Request for Class II Permissive Change(C2PC)

FCC ID: VG8XC034AYYY

This is a C2PC application for which the previous grant was issued on 07/01/2022.

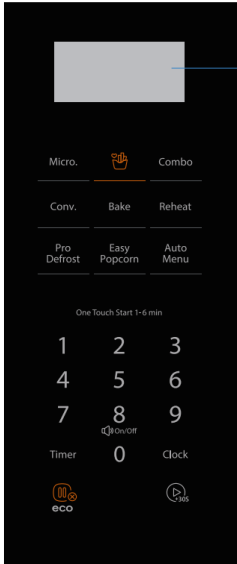
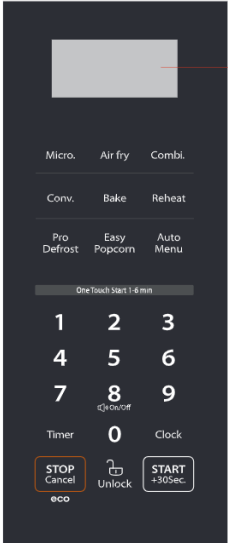
No.:	Original	New	Difference(s)
1			Keypad: Updated front keypad to accommodate child lock function (Child resistant oven door function)
2			Mother board: Modified the peripheral circuit (non-RF circuit) and some individual components and PCB layout. The magnetron and other circuit are exactly same as before
